# County of Fairfax, Virginia

Re: Interpretation for RZ 82-P-044; Tax Map 49-4 ((1)) 59;  
7700 Arlington Boulevard: Site Modifications

Re: Request for Approval of Minor Modifications  
RZ 82-P-044 concurrent with SE 82-P-048  
Fairfax County Tax Map Reference: 49-4 ((1)) 59 (the "Subject Property")  
Applicant: GBA Associates

**NORTH BUFFER ENHANCEMENT EXHIBIT**

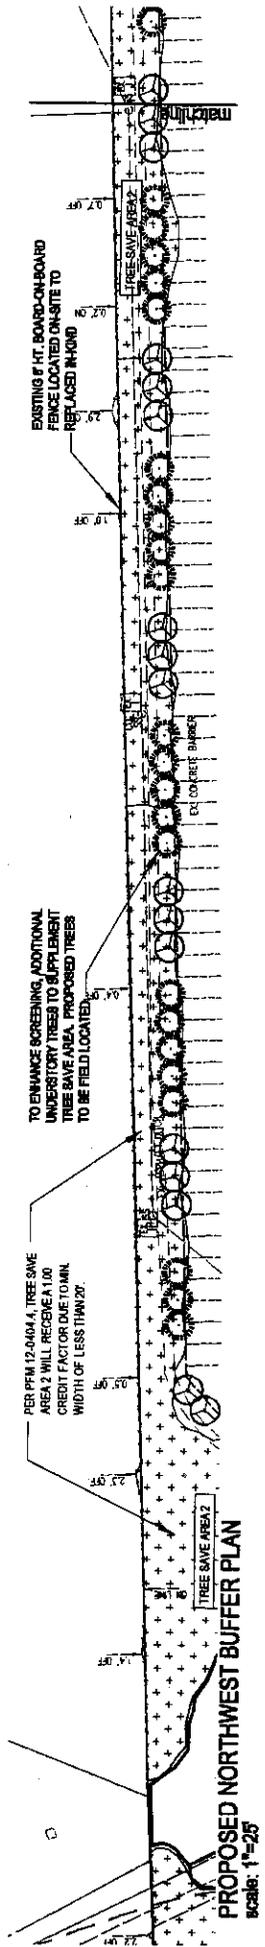
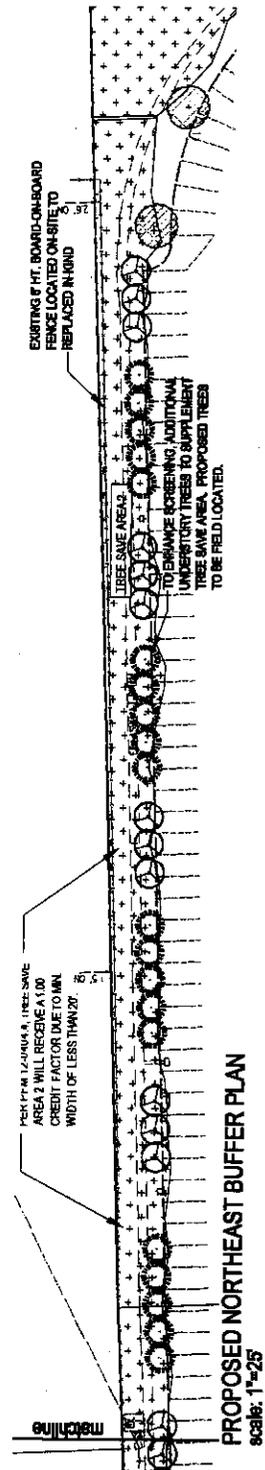
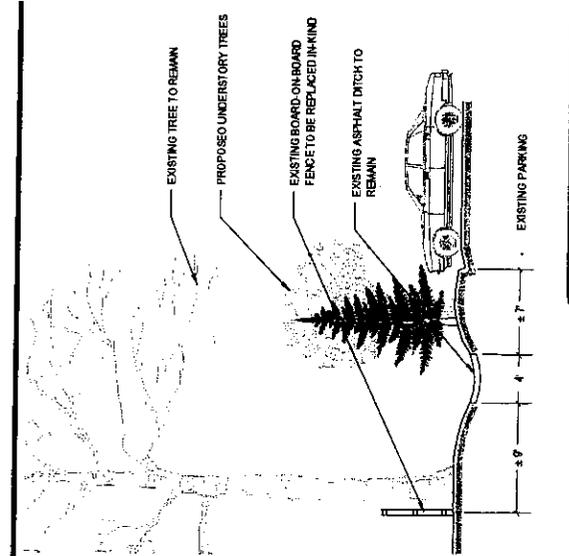
**Landscape Buffer North.** A 35-foot wide transitional screening and landscape buffer along the northern boundary line was proffered (Proffer 2) with the rezoning of the property in 1982. The northern property boundary is adjacent to single-family attached dwellings and a public school. A 1988 As-Built Site Plan (Exhibit 2) depicts a 20 foot wide buffer rather than 35 feet as proffered. The 20 foot wide buffer, with the addition of a fence, and adjacent parking spaces have existed since that time. In 2003, a minor site plan was approved, in which DPWES approved a modification to allow a 20 foot transitional screening yard with the condition that the wooden fence be replaced with a 7 foot tall board-on-board fence and the existing vegetation supplemented to fill in areas of sparse vegetation and to satisfy the purpose of transitional screening. You indicate that with the current proposal, the applicant will continue to meet the transitional screening requirement within the existing 20 foot buffer by supplementing the existing vegetation and mature trees along the northern boundary with new plantings to provide appropriate screening (Exhibit 3, titled "North Buffer Enhancement Exhibit," dated March 13, 2012) and will replace the existing wood fence, as required with the modification approved by DPWES in 2003, to ensure appropriate screening between the existing uses.

A 35 foot landscape buffer was identified in the proffers and the generalized development plan (GDP) approved with the rezoning. The existing buffer along the northern property line was less than 35 feet wide at the time of rezoning, and its 20 foot width has been the same for almost 30 thirty years. In fact, the buffer is shown on an as-built site plan approved by Fairfax County on January 29, 1988 as approximately 20 feet, a copy of which is enclosed. (Exhibit 2) The buffer has never been more than approximately 20 feet due to parking located along the northern property line.

While the Applicant is unclear as to the origination of the requirement to provide a 35 foot wide buffer, it may have been proposed as the typical transitional screening yard requirement between single-family attached dwellings and office development. The northern property line is shared with both single-family attached dwellings and a school. The Applicant proposes to meet the intent of the transitional screening requirements within the existing buffer width. Urban Engineering, which is the firm that submitted the minor site plan, has prepared an exhibit entitled "North Buffer Enhancement Exhibit" dated March 13, 2012 that is enclosed. (Exhibit 3) Exhibit 3 illustrates the improvements proposed on the northern property line. Exhibit 3 details how existing mature vegetation along the northern property line will be supplemented with new plantings to ensure appropriate screening. In addition, the Applicant will replace an existing wood fence located on the property line with a board-on-board fence. These two features combined will ensure appropriate screening between the existing uses and is in substantial conformance with the proffers and the approved GDP.

It is my determination that the proposed supplemental landscaping and the replacement of the wooden fence within the northern buffer are in substantial conformance with the proffers and GDP, subject to final approval by Urban Forest Management (UFM), DPWES.

EAST BUFFER ENHANCEMENT EXHIBIT

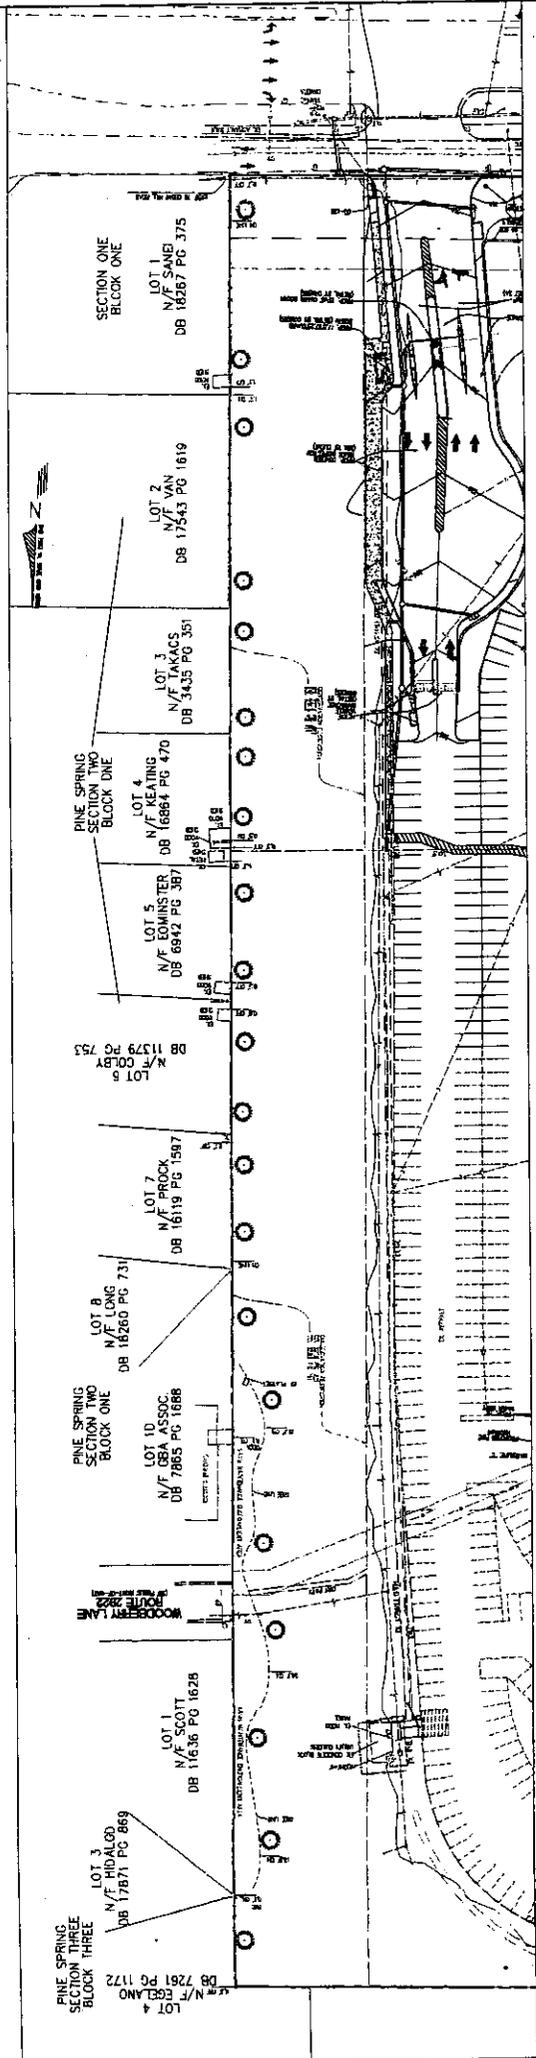
**Landscape Buffer East.** An existing 90-foot wide buffer, required by the proffers, extends along the east property boundary adjacent to residential uses. One of the two guard booths at the Route 50 entrance, and its related canopy and lighting, is located directly adjacent to the buffer. The canopy overhang extends into the buffer slightly. According to your letter, the applicant proposes to plant supplemental evergreen trees within the buffer area to enhance the existing screening, as coordinated with Urban Forest Management (see Exhibit 5, "East Buffer Enhancement Exhibit," dated April 4, 2012, prepared by Urban Engineering).

Lastly, a 90 foot buffer is existing along the eastern property line. A 90 foot buffer has consistently been shown on the GDP and approved plans as screening to the adjacent residential community. The Applicant proposes the planting of supplemental evergreen trees within the buffer area to enhance the existing screening. Given the dense characteristic of the existing vegetation, the Applicant will coordinate with a representative of the Urban Forestry Division to field locate the trees in a manner that will not negatively impact existing vegetation. The Applicant proposes evergreen trees in order to provide year round screening, and will coordinate with a representative of the Urban Forestry Division to select the most appropriate species. The landscaping along the eastern property line is shown on the enclosed exhibit entitled "East Buffer Enhancement Exhibit" dated April 4, 2012 prepared by Urban Engineering. (Exhibit 5) The

It is my determination that the proposed supplemental landscaping would be in substantial conformance with the proffers and GDP, provided that it is designed to restore the vegetation within the buffer that may have died or been damaged by construction, and to mitigate the impacts of the proposed improvements, including the guard booth, security activity, related canopy, and site lighting, subject to final approval by UFM, DPWES.

**EXHIBIT**

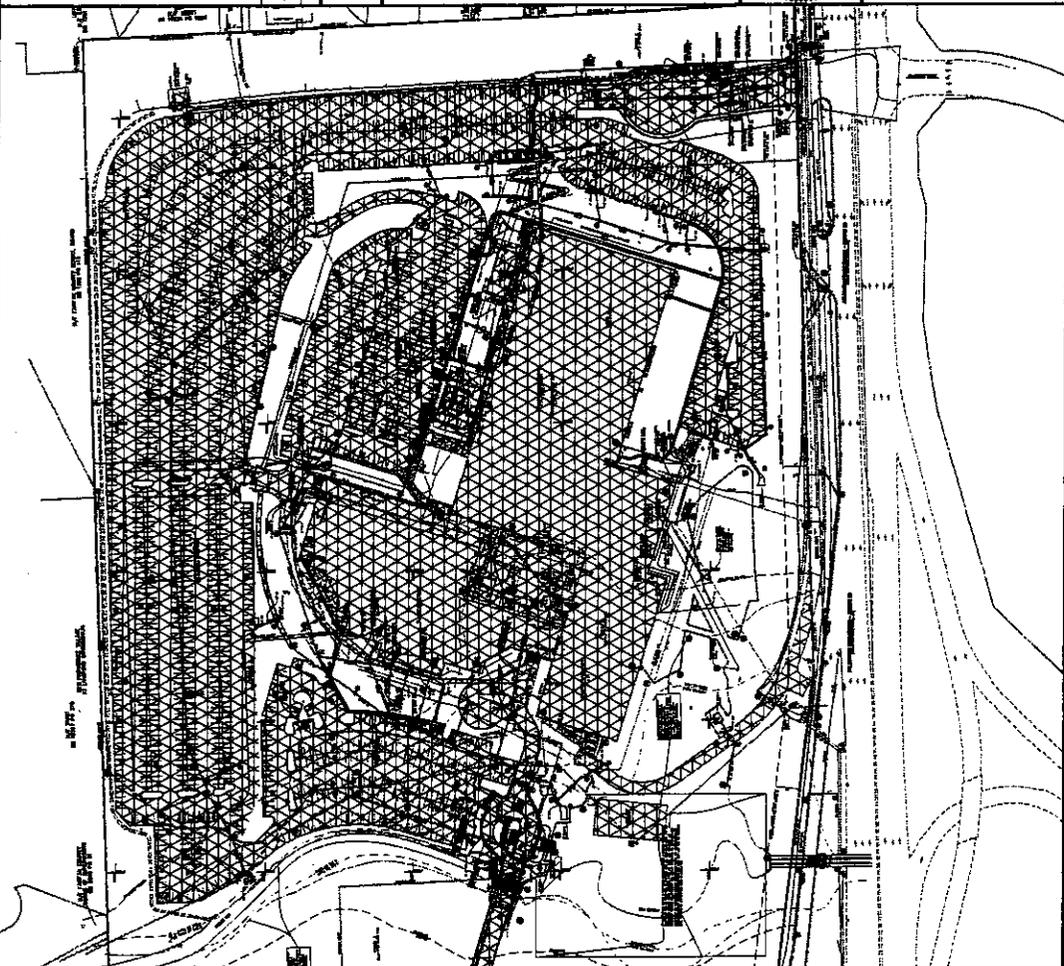
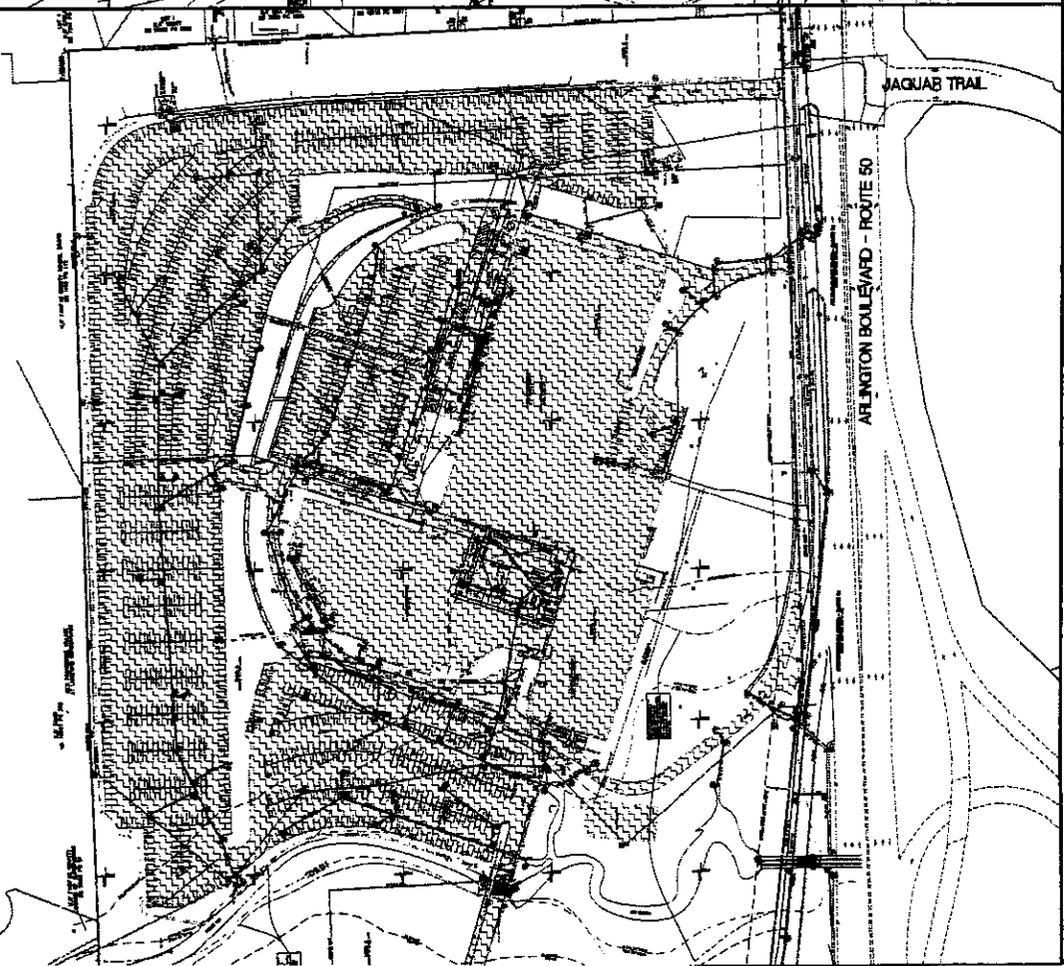
You have indicated that the reconfiguration of parking and entrances has resulted in less total impervious surface, as depicted in Exhibit 6 ("Overall Impervious Area Exhibit," dated April 4, 2012). According to the exhibit, the impervious surface has decreased by 12,416 square feet as a result of the modified site layout, and the overall amount of open space has increased. As depicted in Exhibit 7 ("Open Space Exhibit," dated April 2, 2012), the amount of open space increased by 21,676 square feet, or 2.44%. You have indicated that the GDP depicts approximately 9,250 square feet of tree canopy, which is exclusive of the tree canopy associated with the tree save area within the buffer adjacent to the north property boundary. With the proposed site improvements, the information provided with Exhibit 8 indicates there will be 81,300 square feet of new tree canopy coverage, which is in addition to the 389,780 square feet of tree preservation area on the north property boundary.

It is my determination that the layout modification, entrances, parking and open space would be in substantial conformance with the proffers and the GDP, subject to final approval of DWPEs and VDOT.
